TTi Performance Exhaust and Headers  
Tube Technologies, Inc.  
Corona, California 92880-1726  
Phone (951) 371-4878  
www.ttiexhaust.com

Sheet #306 [Fn21]

## 63-66 A-BODY MODIFICATIONS

Application modifications may apply when using small block step header #TTI636A.

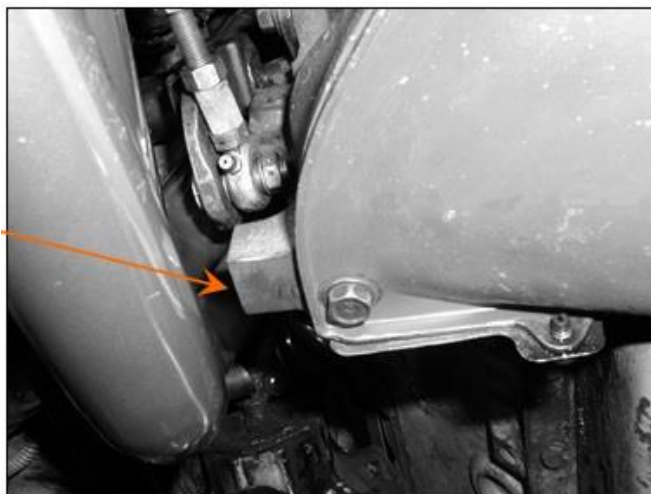
The drivers-side casting ear will require trimming by 3/8" for header tube clearance.

Oil filter adapters are supplied with either a 3/4" or a 1-3/16" hex head mounting bolt. If your adapter came with the 1-3/16" bolt, modification will be required by machining bolt head to .175 thickness.

1-3/16" hex head bolt  
(!) Machining required.

1-3/16" hex head bolt machined  
to .175 thickness.
